CITY OF BEAUFORT HISTORIC DISTRICT REVIEW BOARD PROJECT APPLICATION (Revised - 09/24/2014)

CITY OF BEAUFORT
Historic District Review
Board Full Board
Staff Report
Meeting of December 10, 2014

Case Number: HR14-47
Property Address: 806 Boundary Street
Applicant: 806 Boundary LLC
Type of Request: Alterations, Additions and Bailey Bill Approval - Final
Zoning: GC – General Commercial

53
PORCH BEAM

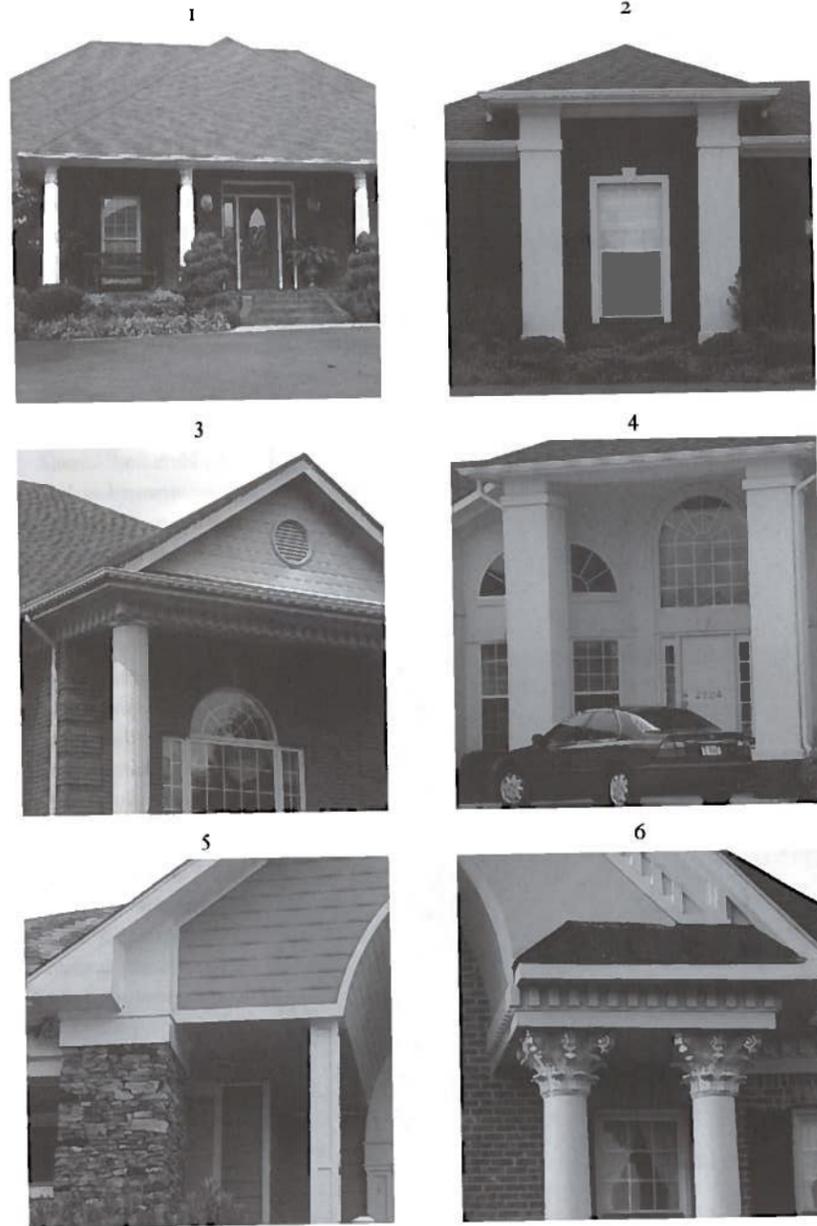
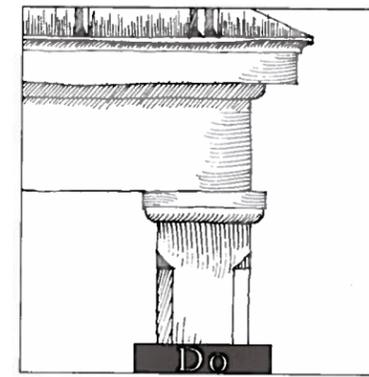
- On the porticos, the beams seem to be too large at just over 2'. Consider reducing the size to 12-14" to achieve a better proportion. This would carry over into the dimension of the trim/decorative panels located below the eaves.

- Also, the end of the beam should align with the face of the column. The eave can protrude past that. See attachment for more details on this.
 - Consider increasing the column widths on the front and rear porticos to 12" to be more in proportion with the rest of the portico Also, see attached detail for ideas on trimming out the cap and the base. In general, the top portion of the capital should not be wider than the column except where there is applied trim. See attachment for more details on this.

67 EAVE RETURN

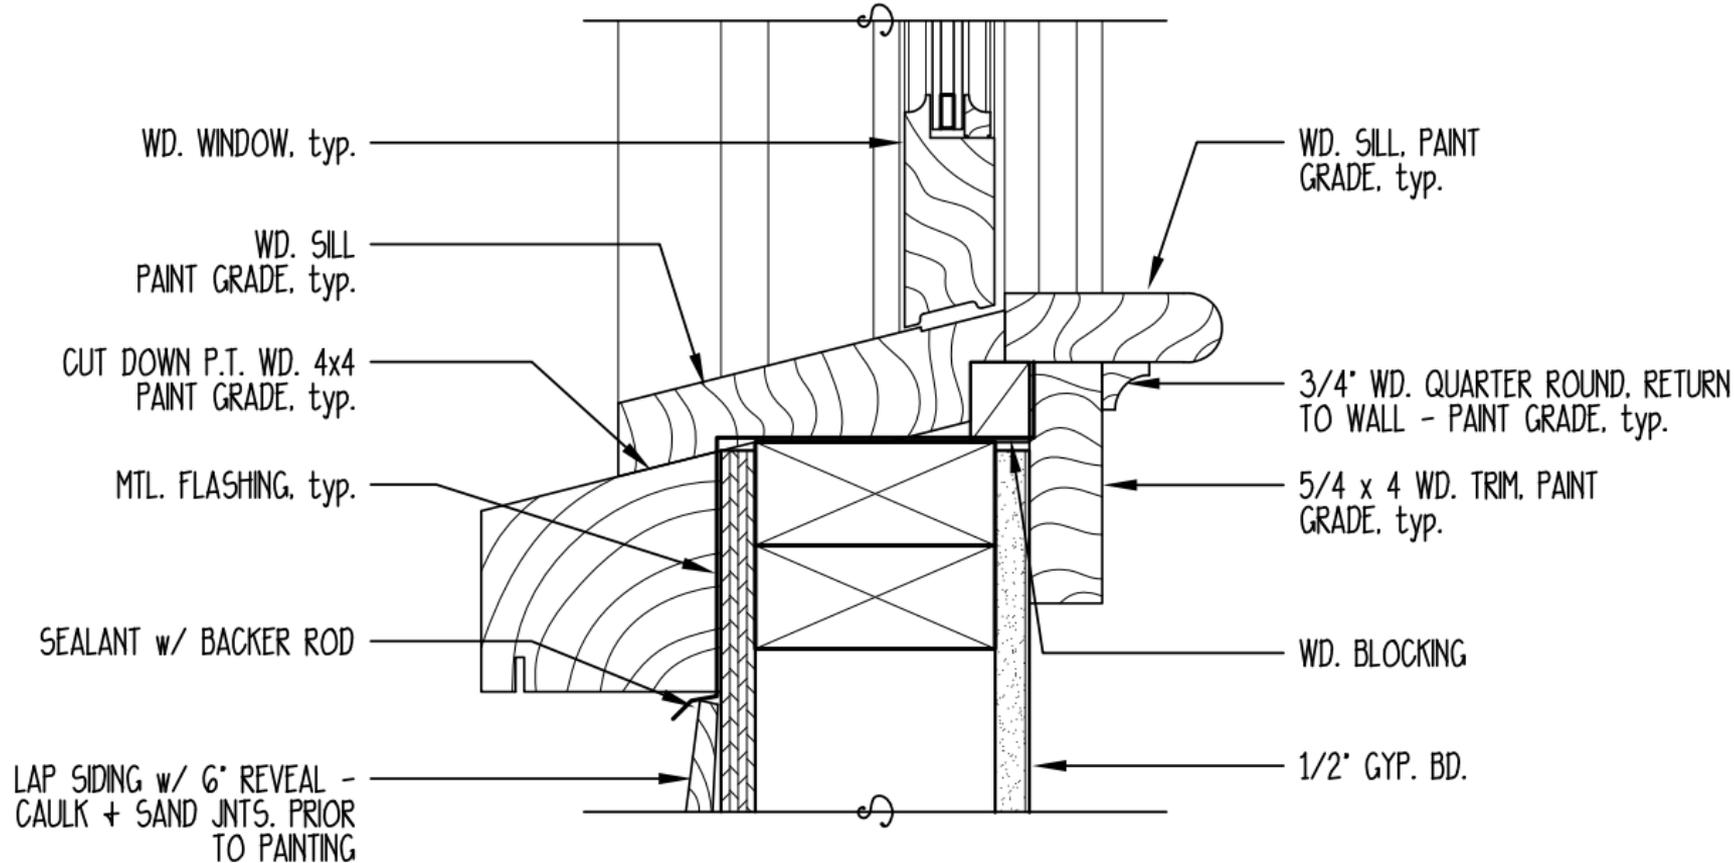
- The rake overhang seems to be too deep at 2'. Consider reducing that to 12".
 - On the eaves, consider either using exposed rafter tails, closed rafter tails (similar to the one story porch at 710 Boundary), or doing a partial return. See attachment for more details on this.

TYPICAL WINDOW SILL

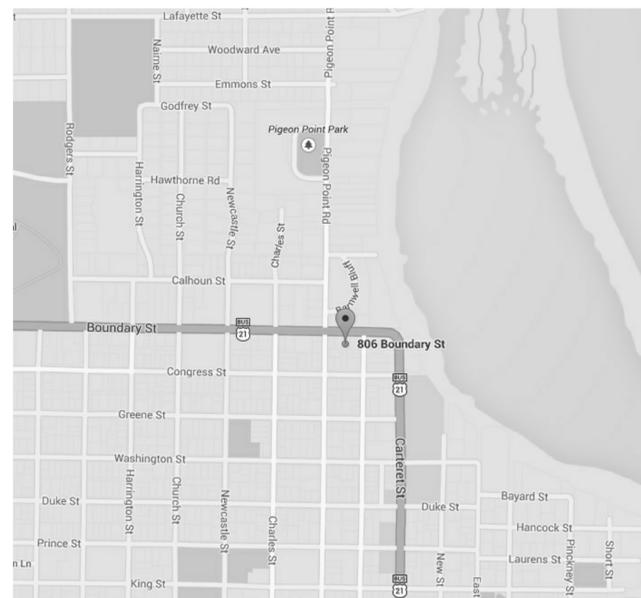
- Consider adding a true wood sill instead of a flat applied trim at the base of the windows. This is a typical detail in this area for both new construction as well as historic buildings. It adds more depth to the window. I've attached a typical detail for this, as well as a general description.

NEW CONDITIONS
 ELEVATIONS

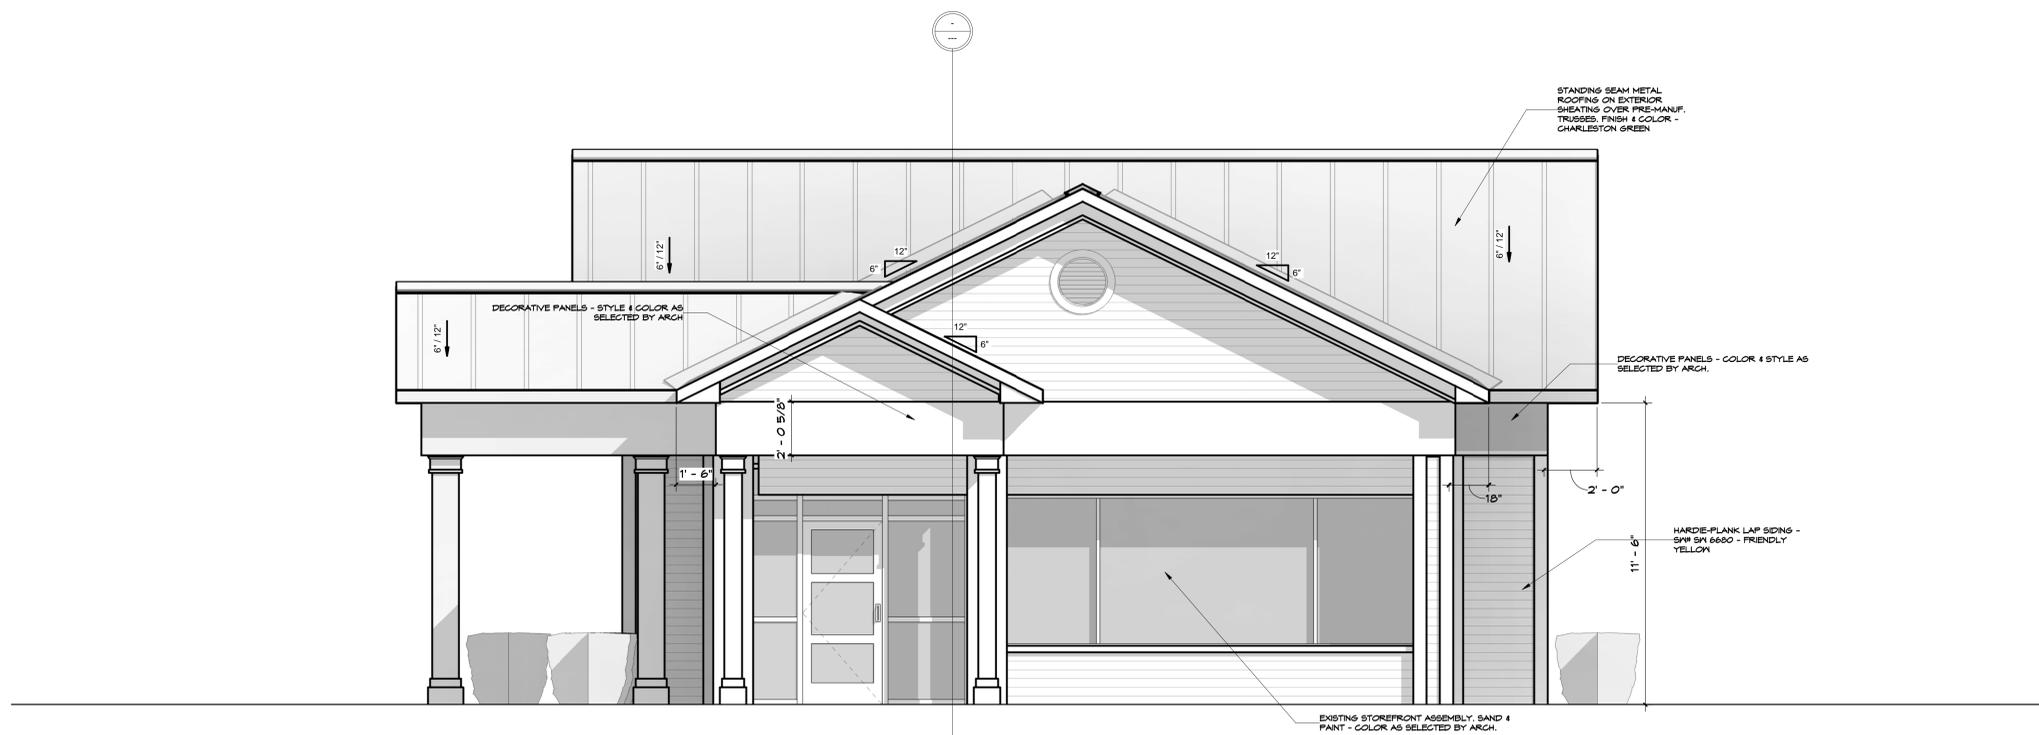
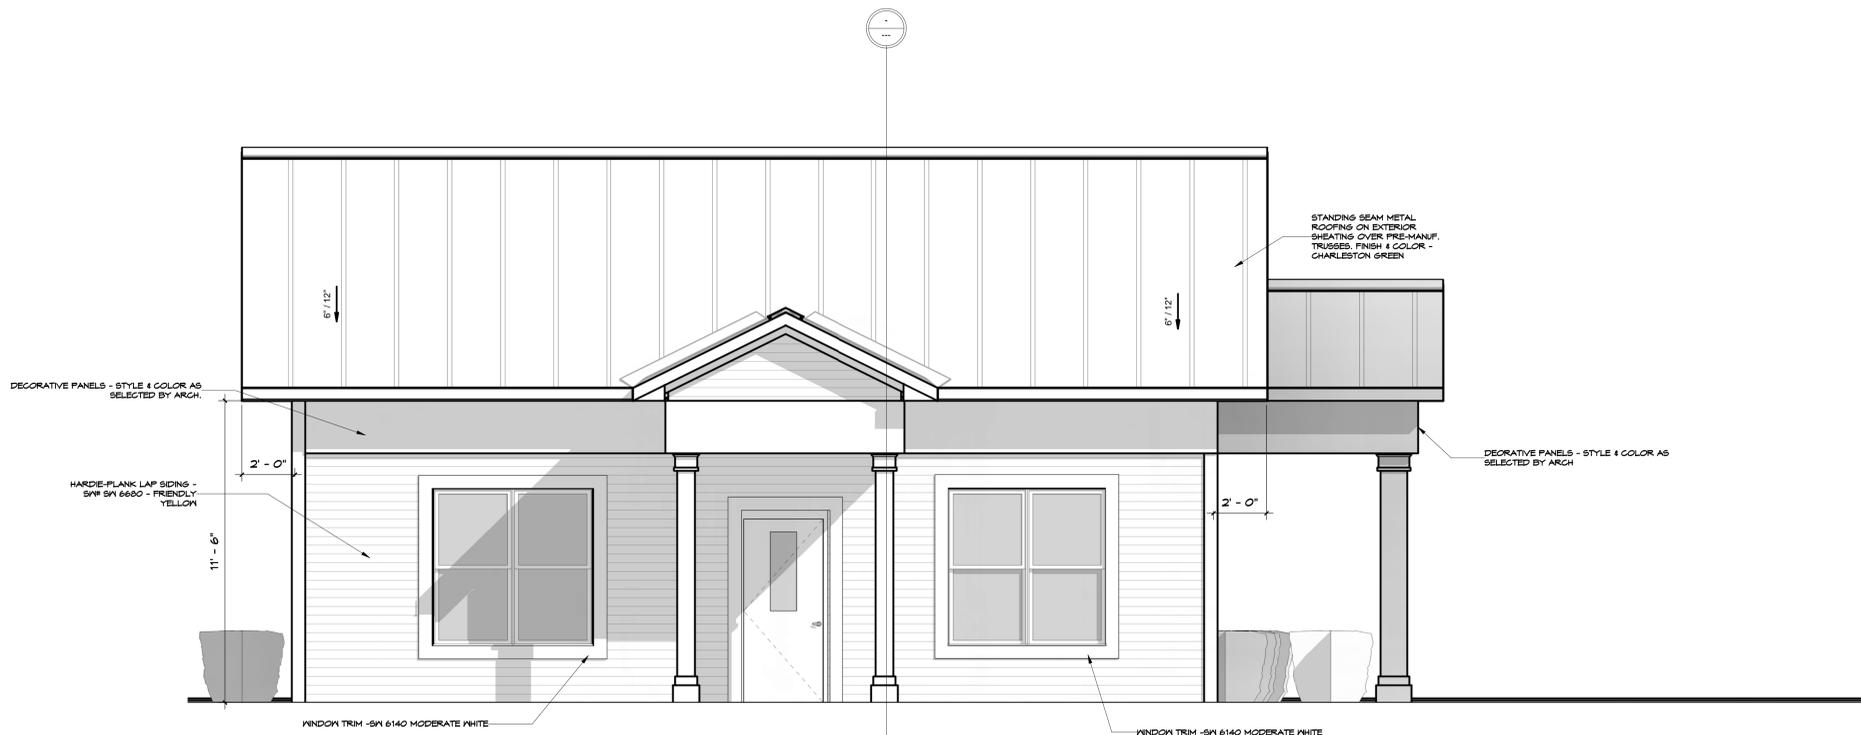
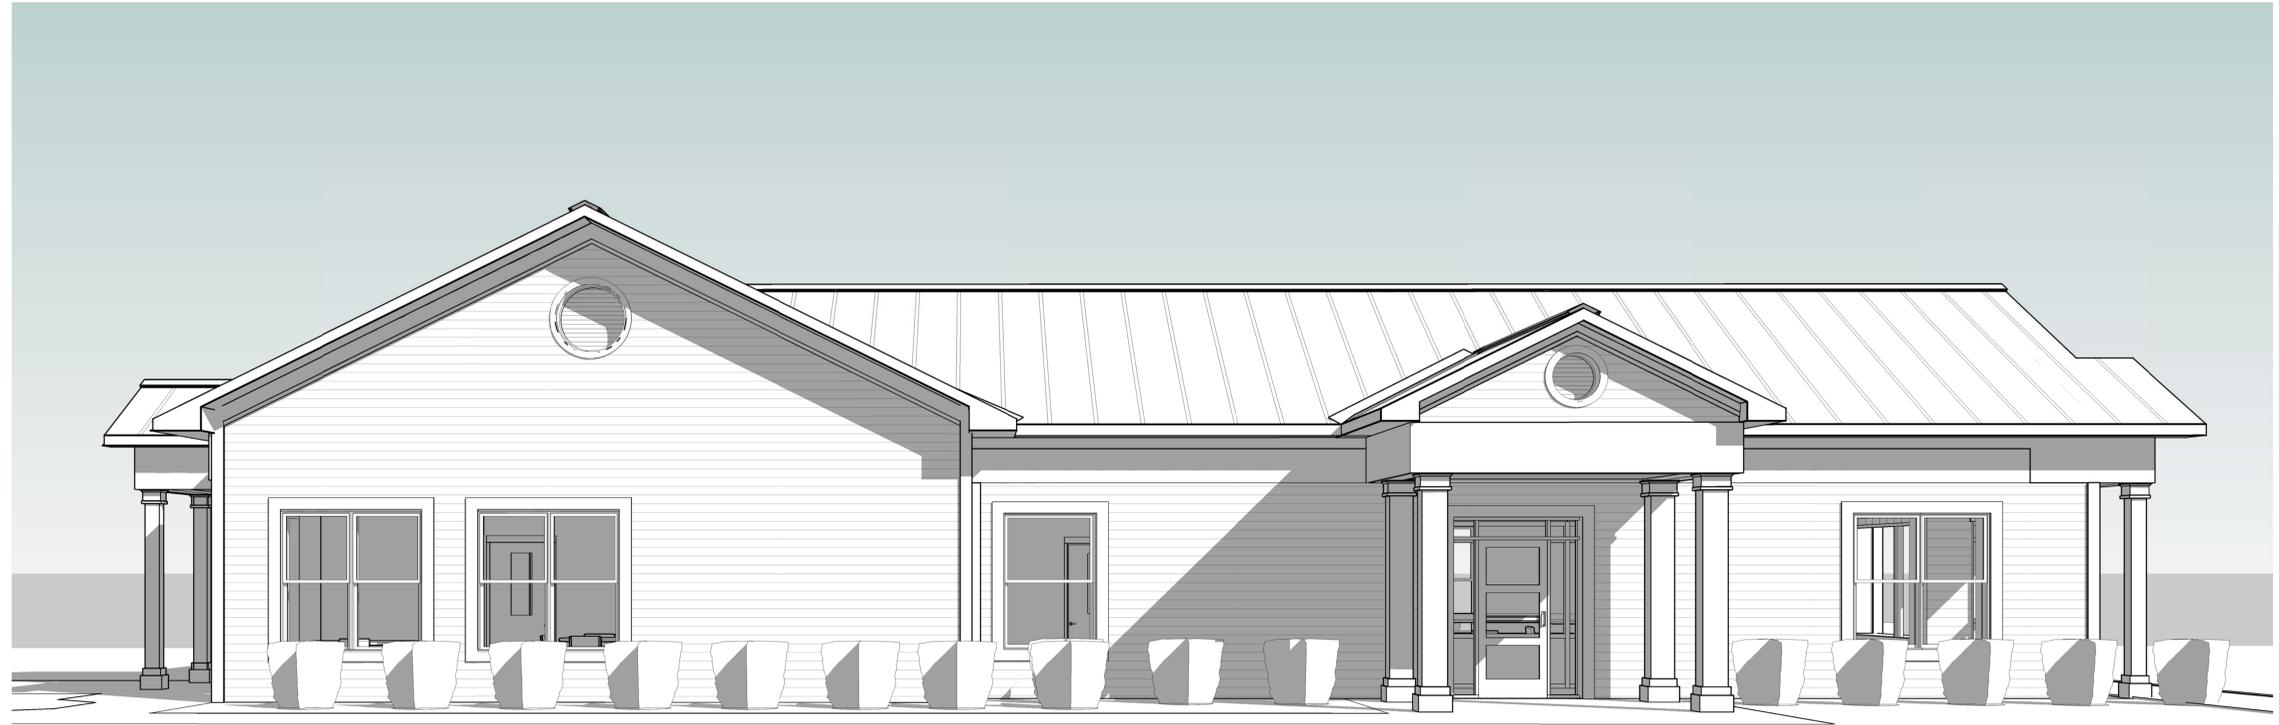
- Building Comments:
 - Please confirm that the door onto Boundary Street will be a usable entrance. This is a requirement of the ordinance.
 - With regards to the new Boundary Street elevation and the entry portico on the east side, the massing of these are well proportioned and composed.

- Consider increasing the roof pitch on the existing building so that the mass of the addition is not taller than the existing structure. An 8:12 pitch should be able to accommodate this 2' differential the board finds it to be important.

- On the east side portico, the roof system can just end at the wall, or at an engaged pilaster. The second column close to the wall is an atypical detail that may not be necessary.
